**Planned Unit Development — Lot 2 Southport East
Replat Two—CPM-SFI Southport, LLC**

RECOMMENDATION REPORT

RE: Planned Unit Development – Initial Review Letter
Lot 2 Southport East Replat Two

Comment Response: Lot 2 Southport East Replat Two

SHEET
C2.1

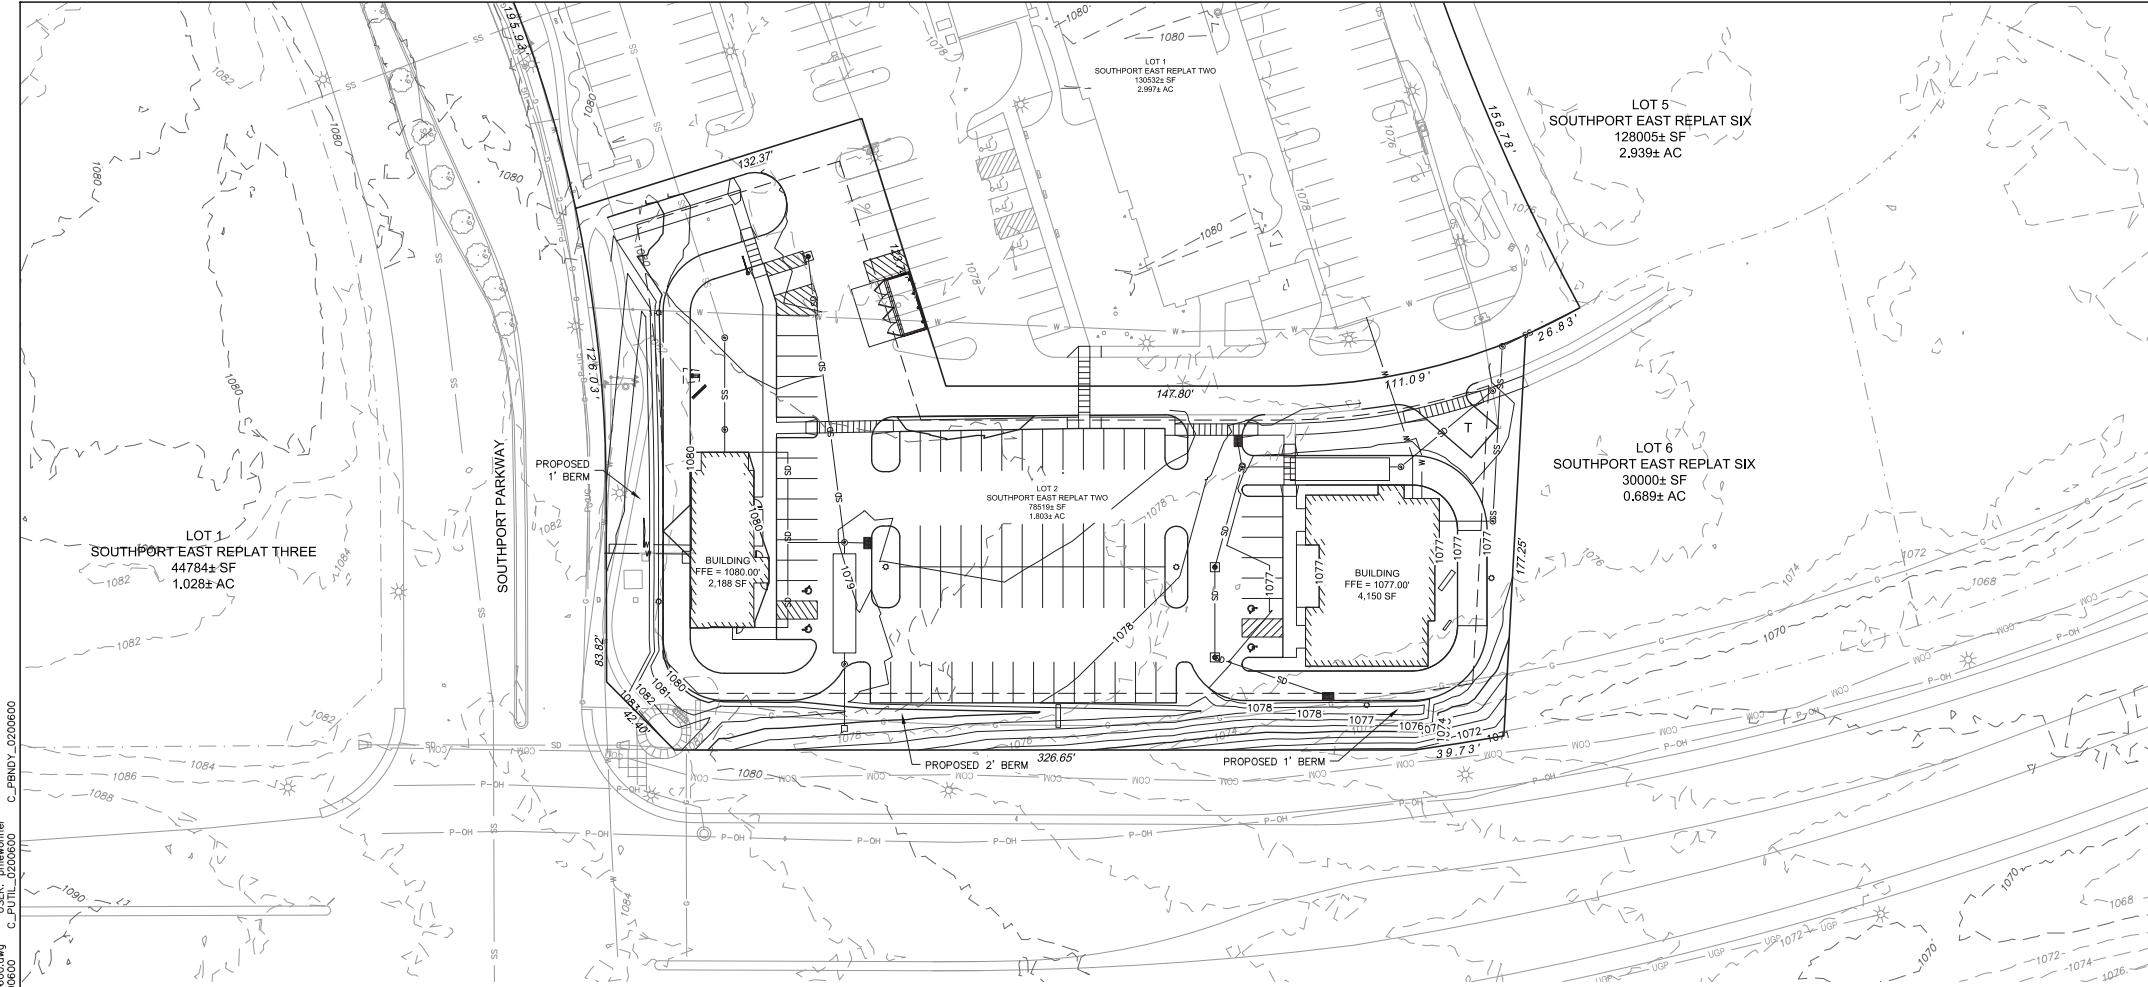
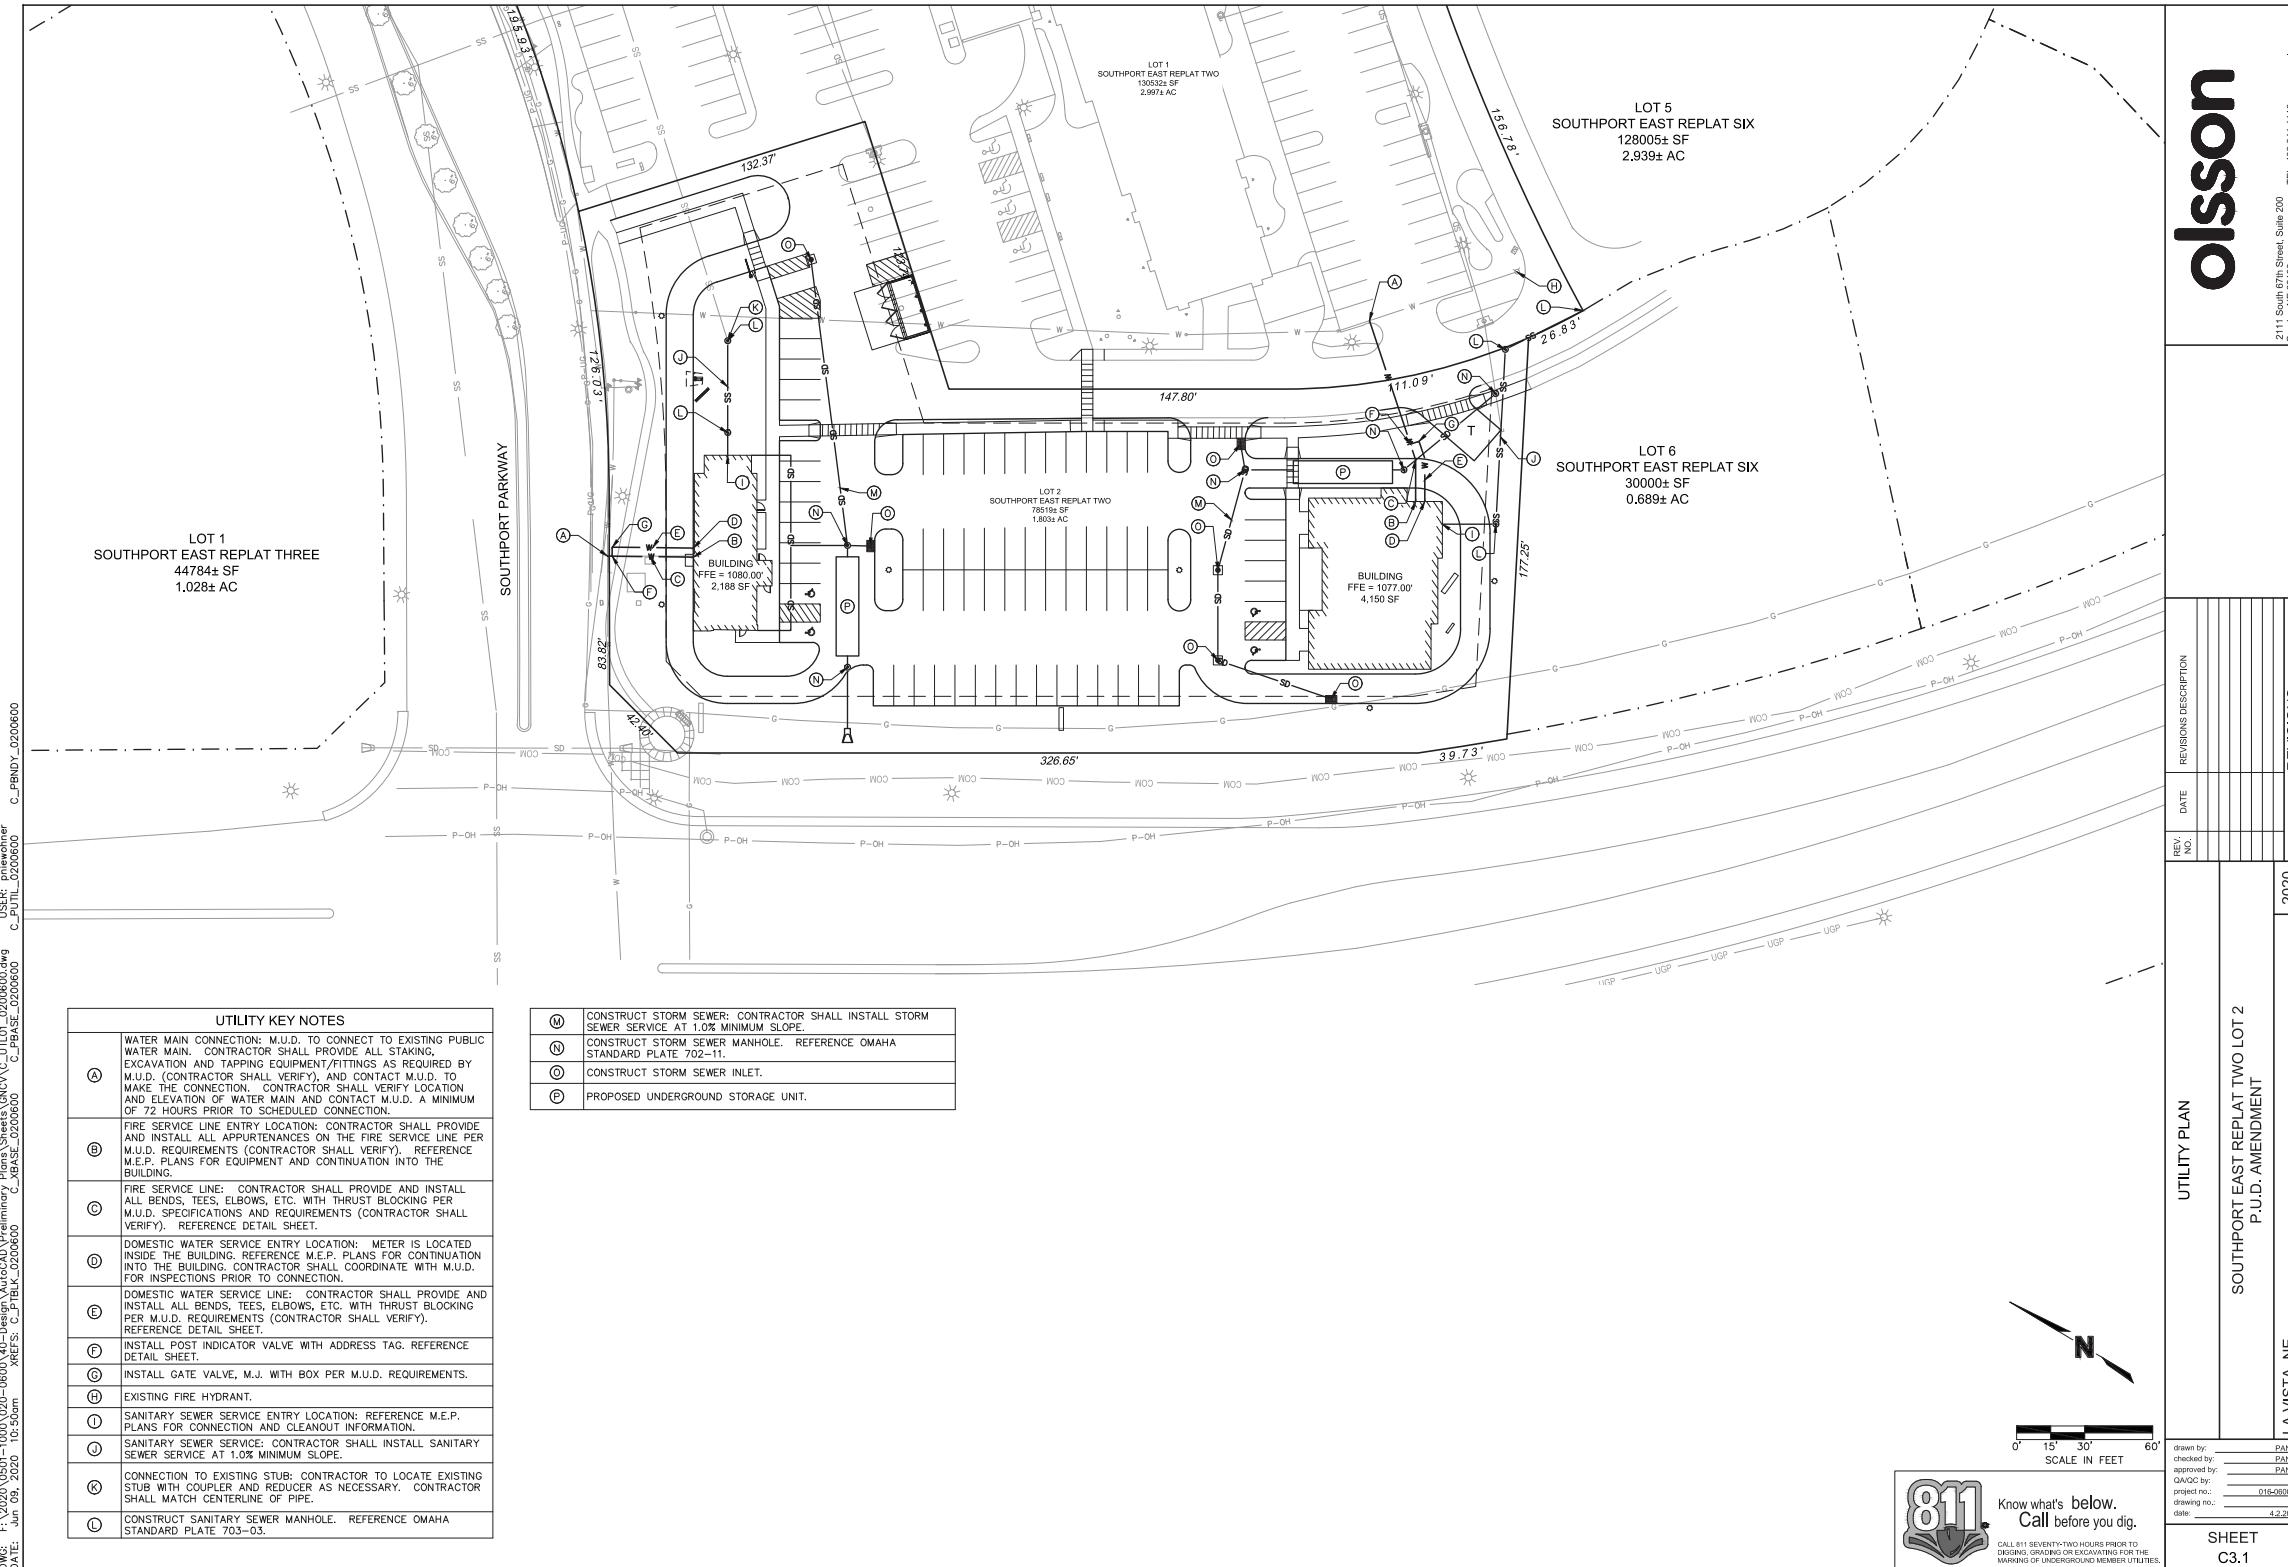
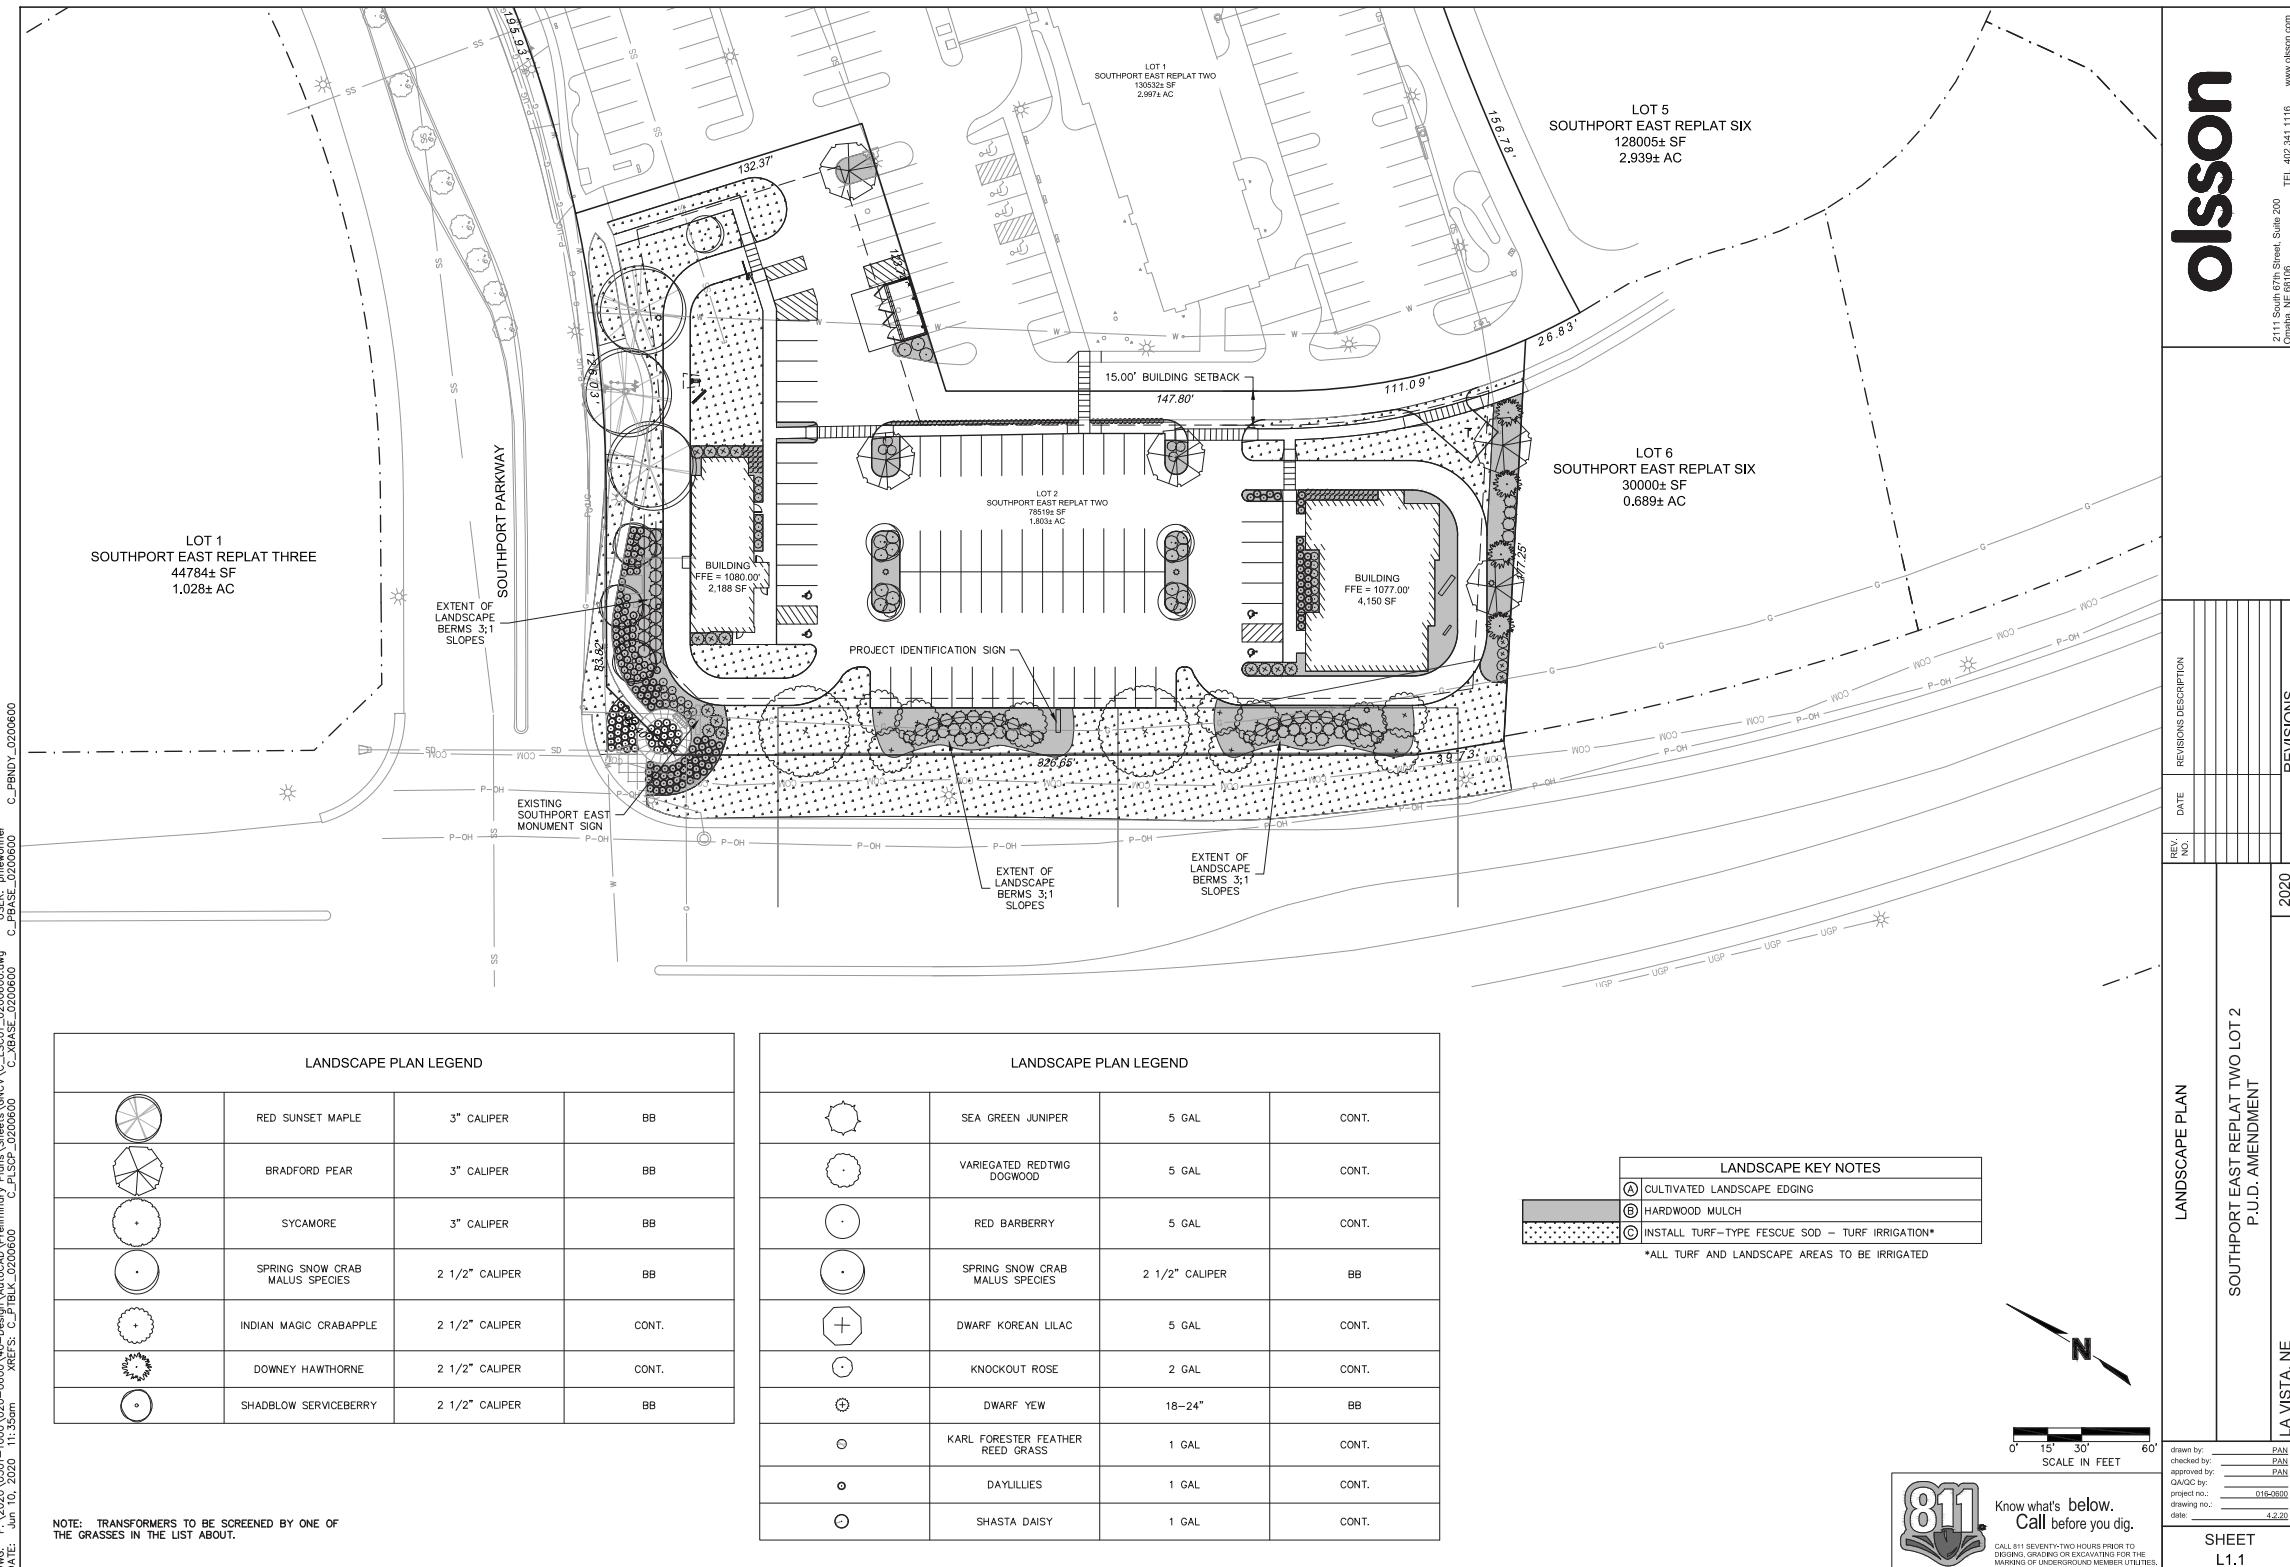
- Grading plan needs to address a conceptual design of water quality and 2-year peak flow detention, such as indication of bio-basins or under parking lot facilities.

- The grading plan submitted does not depict the required berthing of the landscaped areas along Southport Parkway and Giles Road as per the Southport East Design Guidelines.

- Note #4 suggests the proposed grades are in 2' contours, whereas it appears the proposed contours are 1'. Please clarify.

- Labels were added to the grading plan to denote either a 1' or 2' berm along the street frontages, however, the topographic lines do not reflect this berming. Please correct the plan's topographic lines to accurately reflect the berming.

Response: Location of proposed underground detention is shown on sheet C3.1, which will address both water quantity and quality requirements.

Response: Berms are shown on C2.1, although may have been hard to see. Additional information has been added.

Response: Note has been updated for clarity.

Response: Grading has been updated to more clearly reflect this berming.
